February 24, 2016

Following recent discussions about Brick North, below is a summary of site work required for Brick North before Certificates of Occupancy can be issued. The attached color-shaded plans delineate site plan improvements for Brick North. Completion of this work will be considered towards fulfillment of the Level III Site Plan approval The Forefront at Thompson's Point Amendment Phase 1A, PEZ.2014-120 (approved December 4, 2014). This summary applies exclusively to requirements for Brick North. Full execution of the recently approved Level III Site Plan and Subdivision approval, PEZ.2015-133 & 2015-159 (approved January 21, 2106), is required for occupancy of Brick South.

PROJECT  
BRICK NORTH AND SOUTH BUILDINGS AT THE FOREFRONT AT THOMPSON'S POINT  
SHEET TITLE  
SITE LAYOUT PLAN  
CLIENT  
FOREFRONT PARTNERS | LP

AREA B ENLARGED VIEW  
1" = 20'

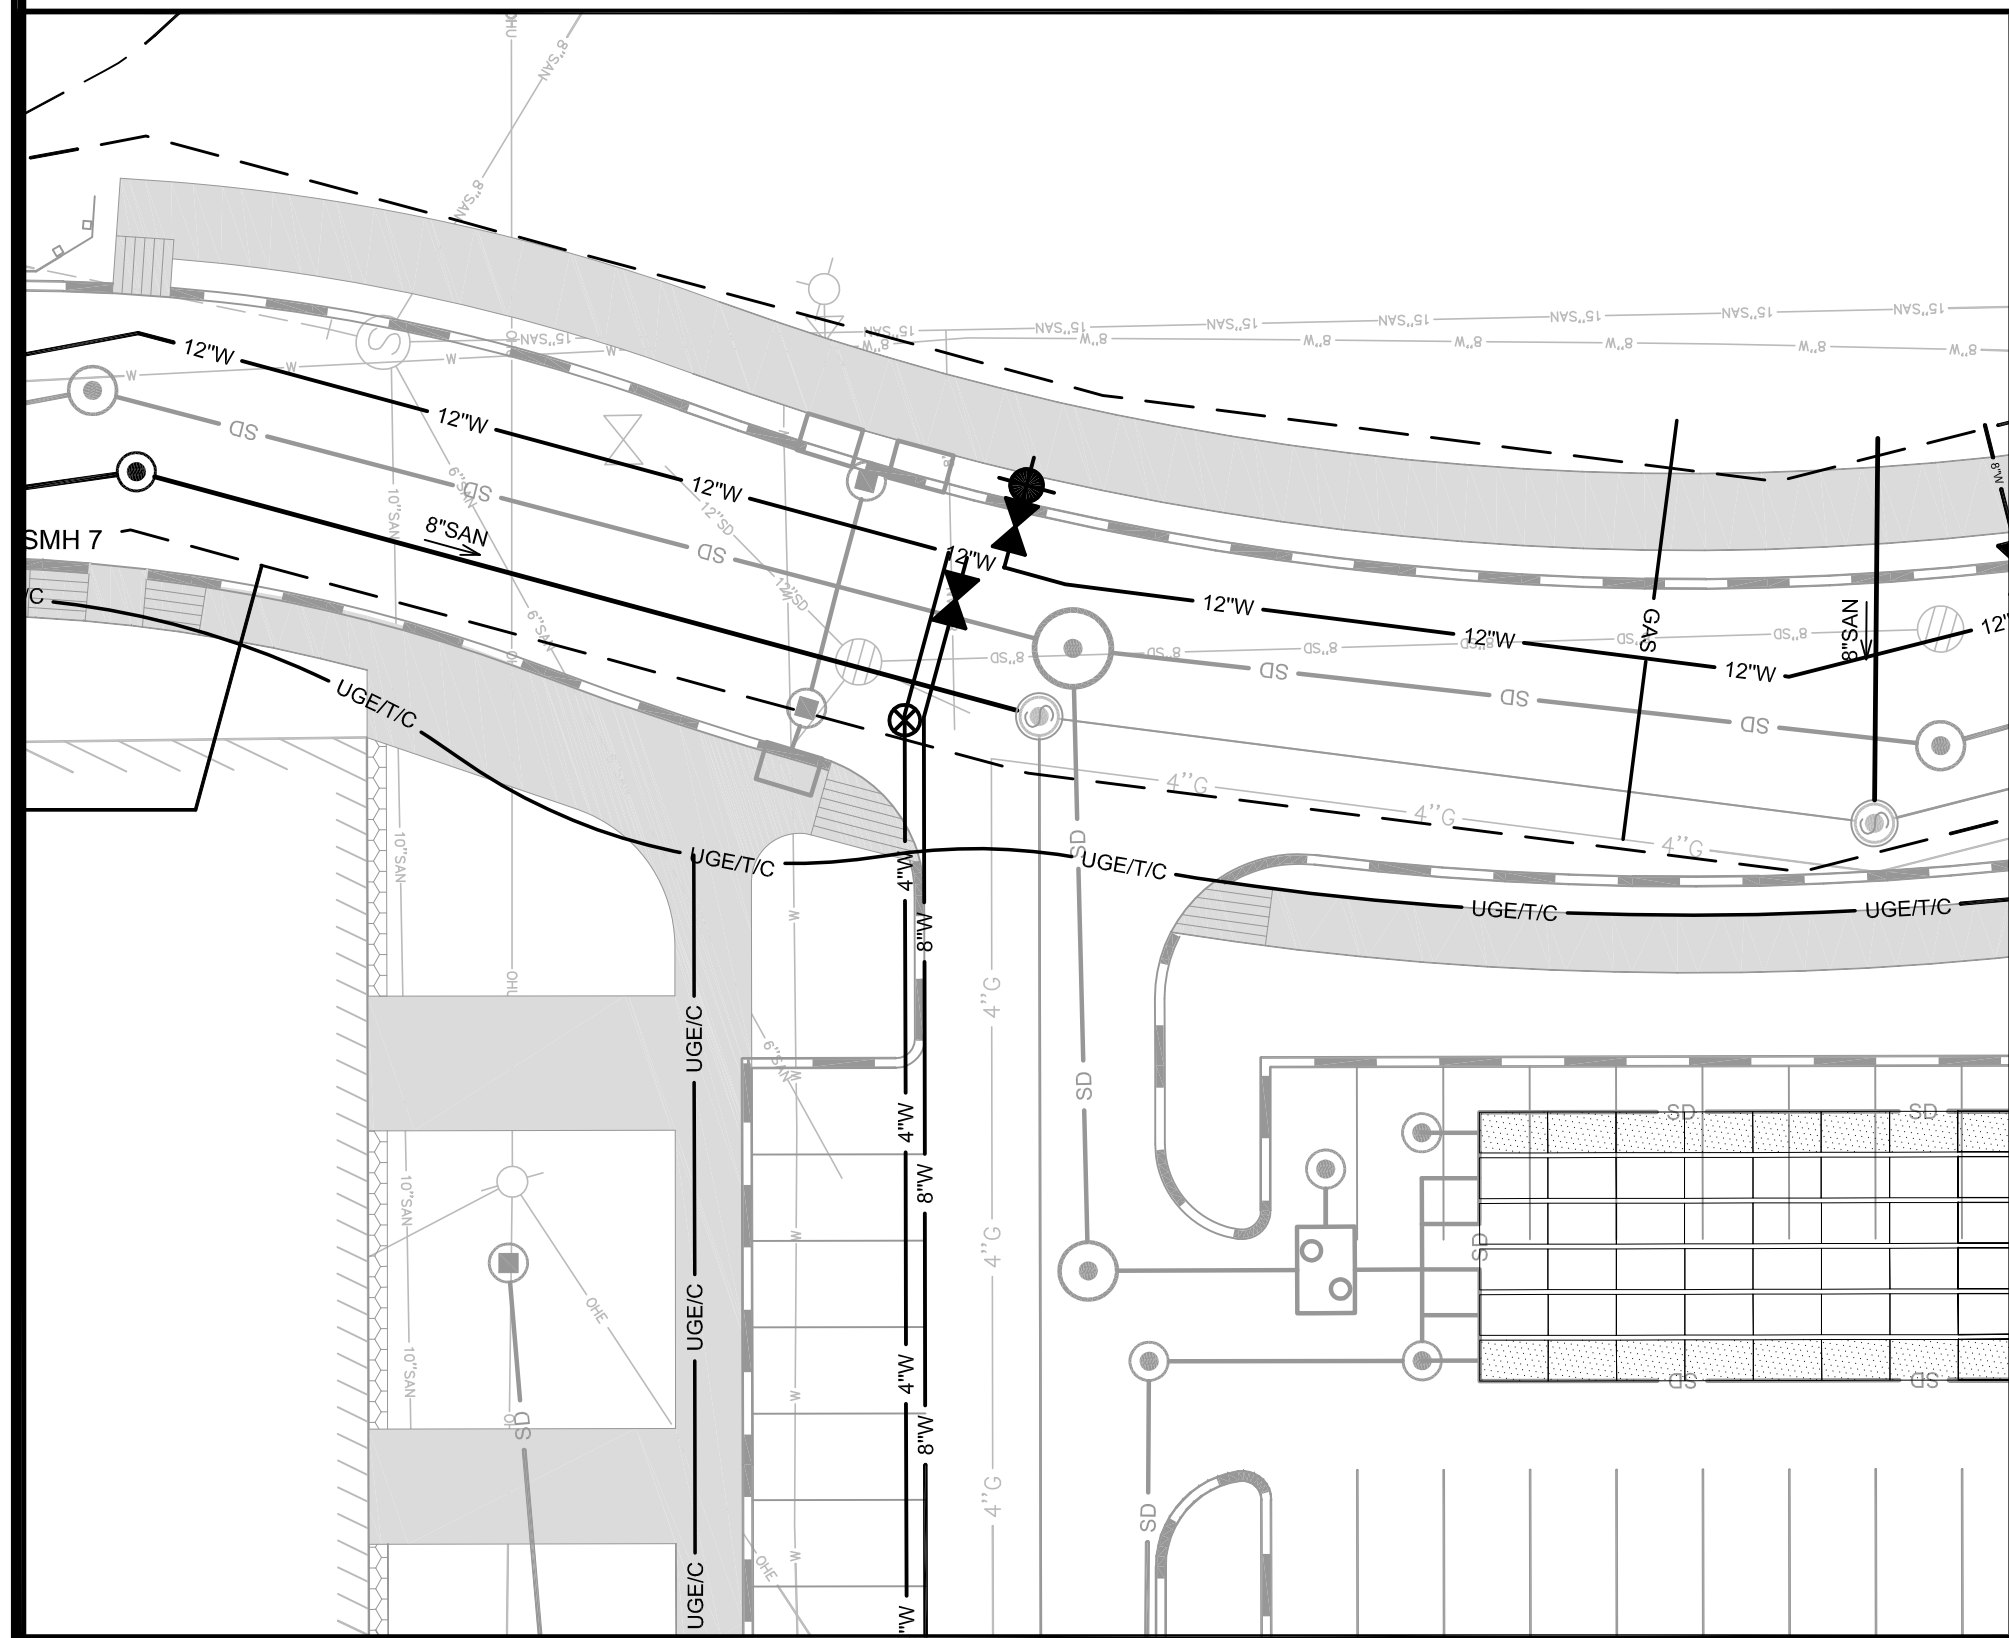
In regard to the areas called out with the notes: *Temporary Protected Designated Walkway* and *Improved Gravel Surface with Temporary Parking Demarcations* on the attached Sheet C-3.0, Site Layout Plan, final details shall be approved by the Planning Authority.

LANDSCAPE PLAN

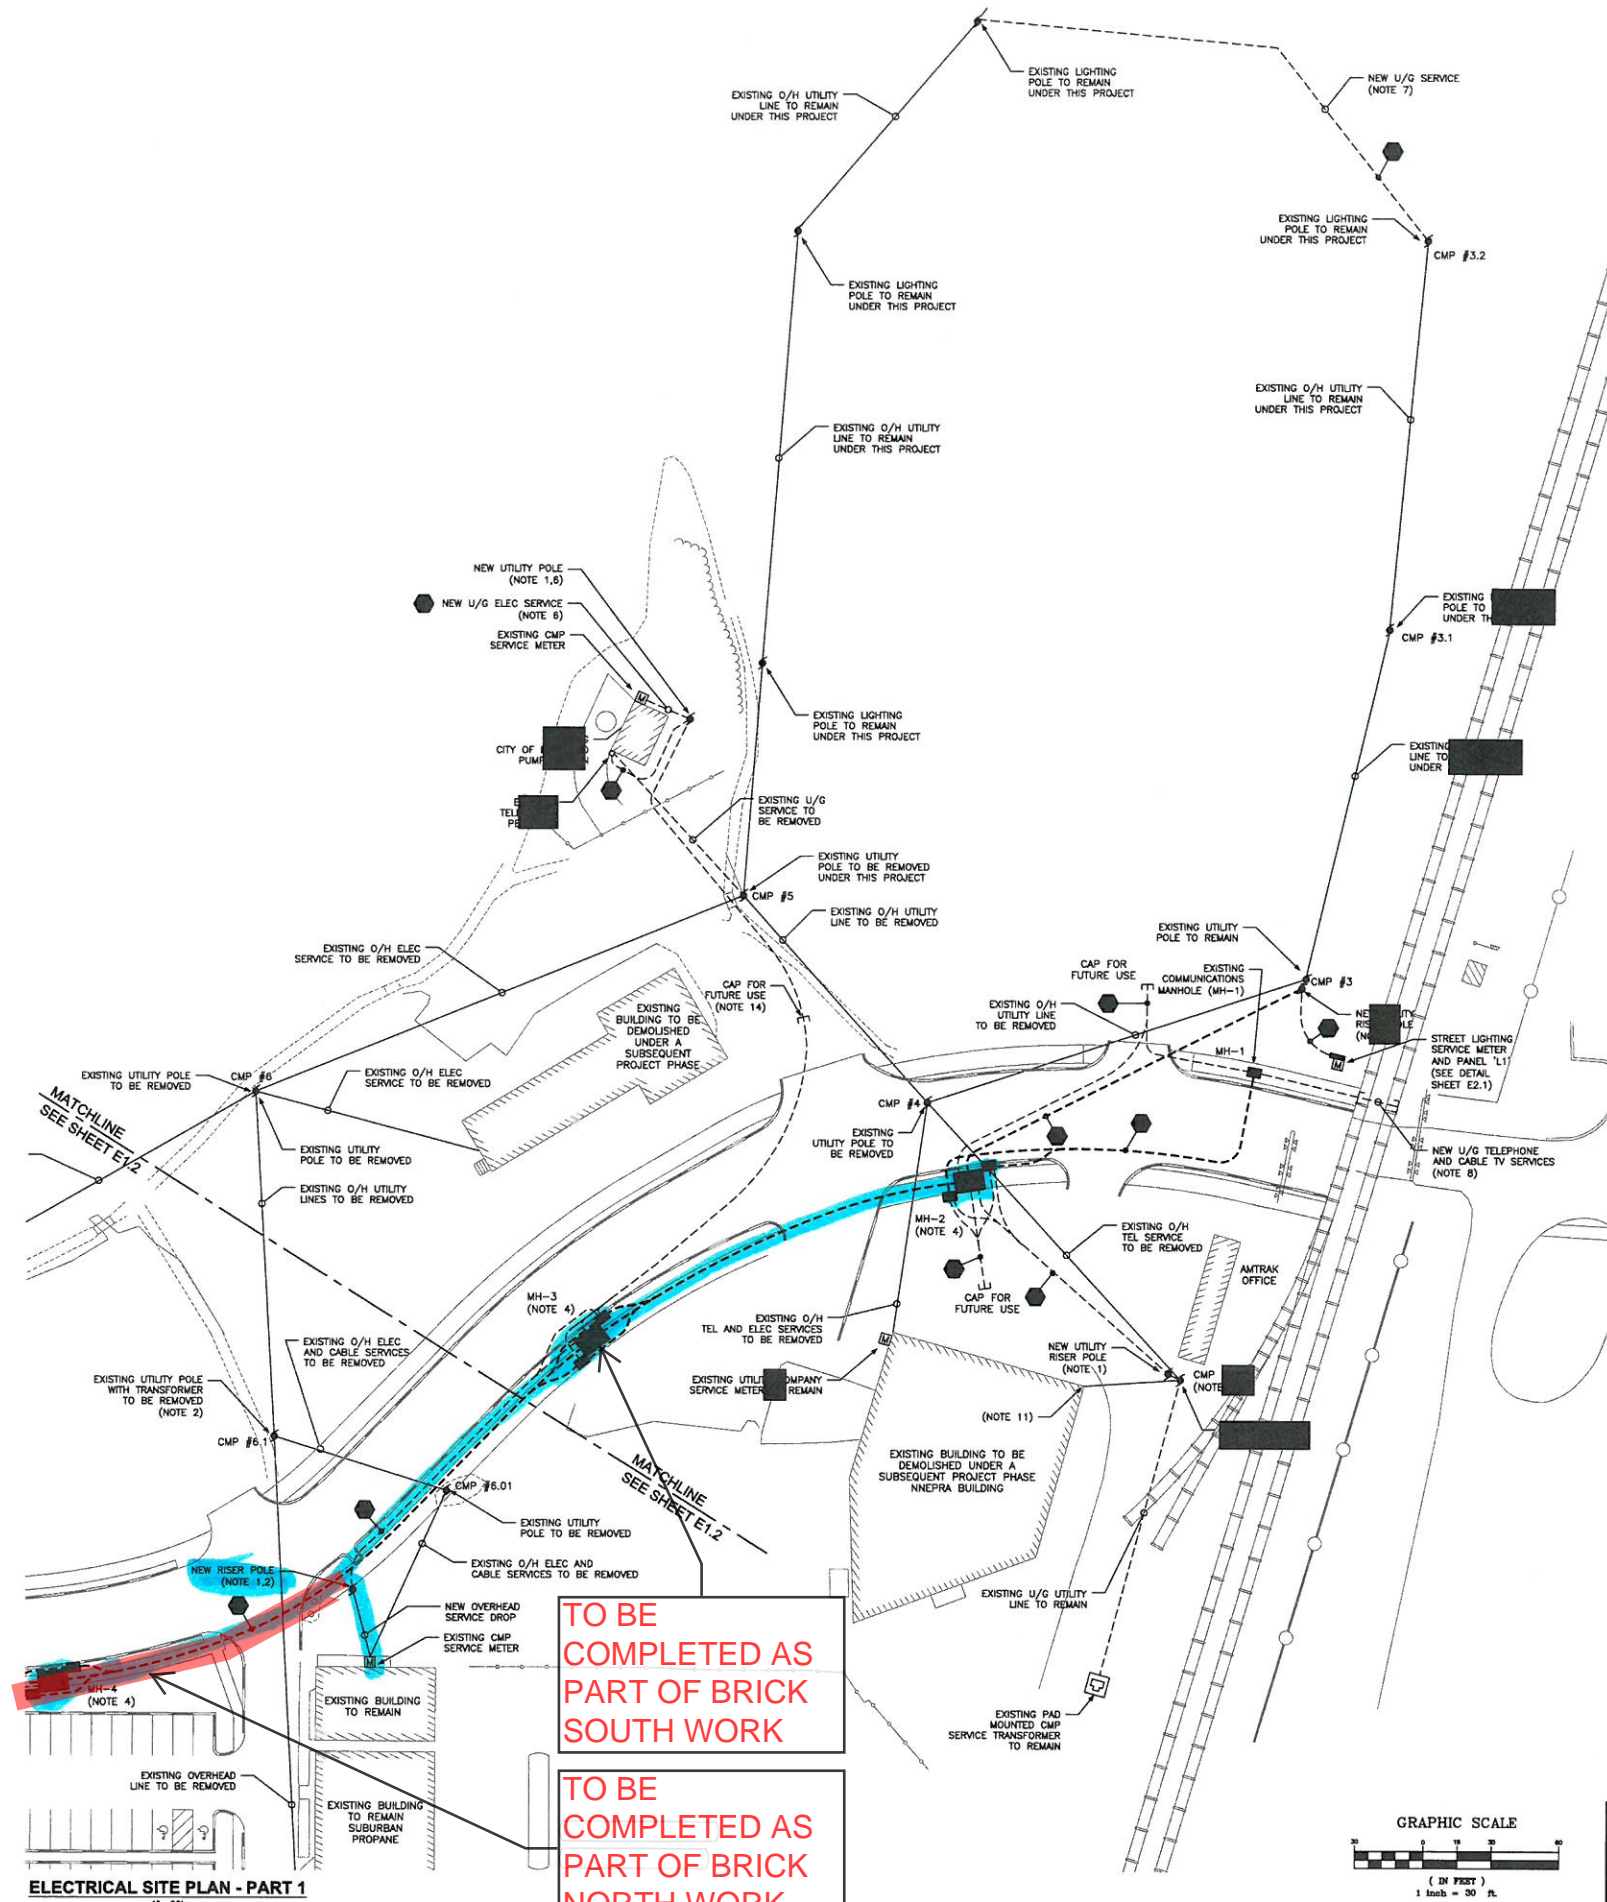
All work shown as shaded on the attached plans shall be completed before any Final Certificates of Occupancy will be issued for proposed new tenants. In the event that either plantings as shown on Sheet L-1.0, *Landscape Plan*, or the final paving course are not complete, yet all other requirements have been met, Temporary Certificates of Occupancy may be issued for new tenants through June 30<sup>th</sup>. The binder course should be appropriately striped to match the approved plans in the interim.
